MILITARY SPECIFICATION

MODULES, STANDARD ELECTRONIC

GENERATOR, FUNCTION, LSB, ANALOG, KEY CODE SHU

This amendment forms a part of MIL-M-28787/187B(EC), dated 20 October 1983, and is approved for use within the Space and Naval Warfare Systems Command, Department of the Navy, and is available for use by all Departments and Agencies of the Department of Defense.

FIGURE 19. Settling time test circuit for table XIV.

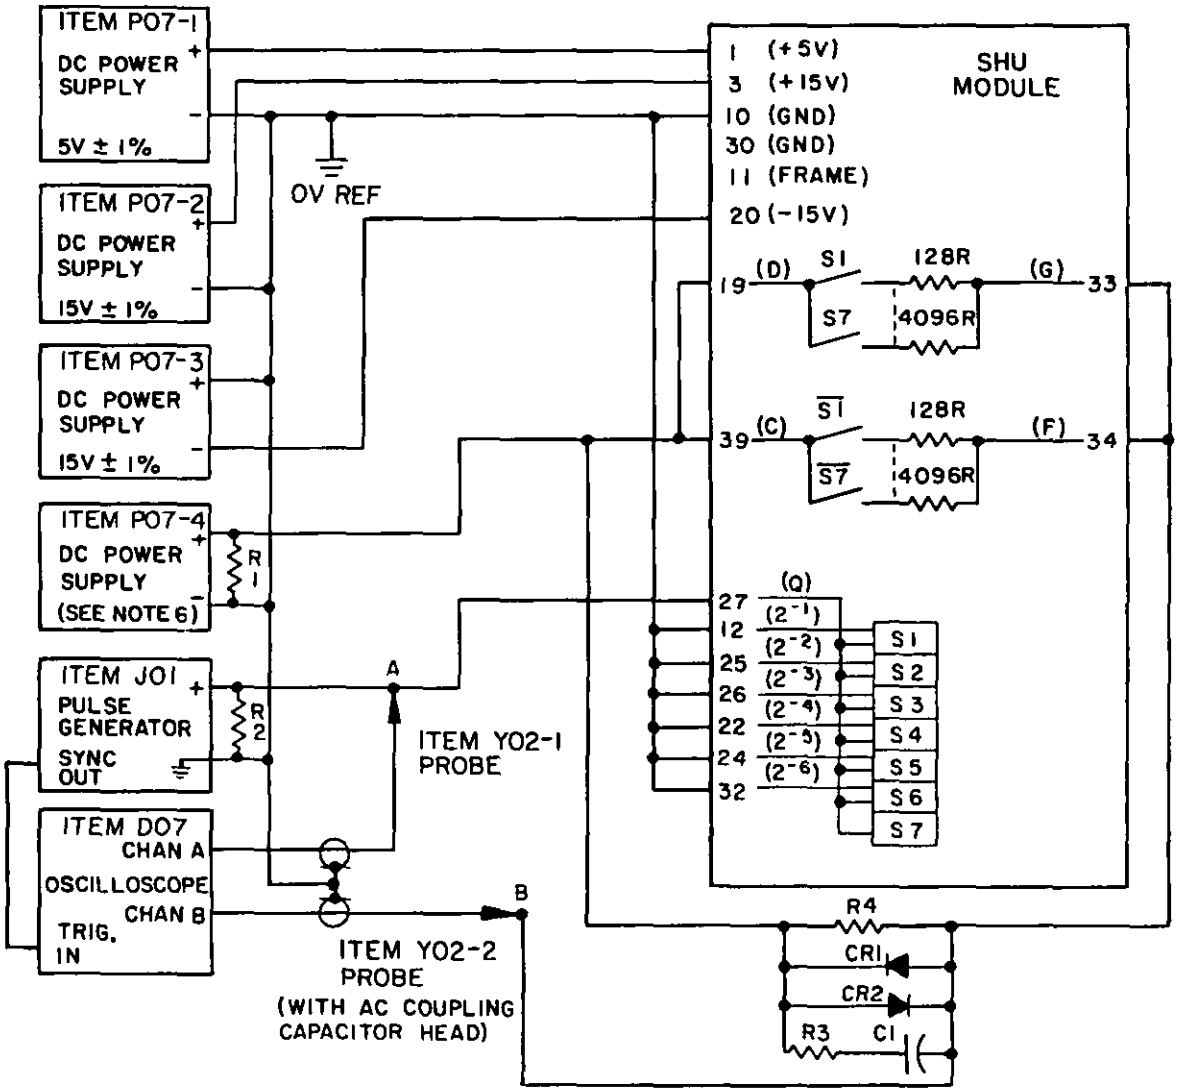
FIGURE 19: Delete and substitute new figure 19 as printed on page 2 of this amendment.

NOTES:
1. R1 = R2 = 50Ω ±5%, 1 W.
2. R3 = 750Ω ±1%, 1/8 W.
3. R4 = 777Ω ±0.1%, 1/8 W.
4. C1 = 220 pF ±5%, 20 WV dc.
5. CR1 = CR2 = 1N4148, or equivalent.
6. For test conditions N1 and N2, adjust item P07-4 for 6 V ±1% and for test conditions N3 and N4, adjust item P07-4 for 1.1 V ±1%.
7. Item D07 shall be ac coupled so that channel B can be amplified for maximum amplitude or a dc voltage can be subtracted by means of a differential comparator. Verify that channel B output amplitude stays within ± 1 mV of its settled out value.
